# SITE PLAN REVIEW

LOT NO 151..... REGISTERED PLAN

**NORTHGLEN PHASE 2  
CLARINGTON, ONTARIO**

## SITE GRADING PLAN

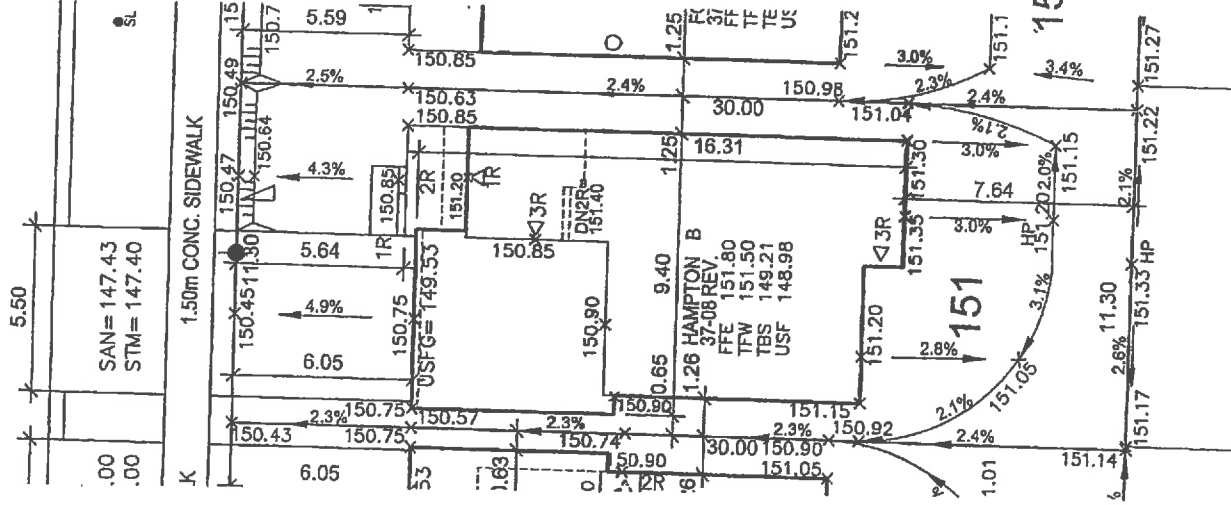
THE PROPOSED LOT GRADING AND DRAINAGE IS APPROVED AS BEING IN CONFORMITY WITH THE OVERALL APPROVED GRADING PLANS FOR THE SUBDIVISION.

NO COMMENT
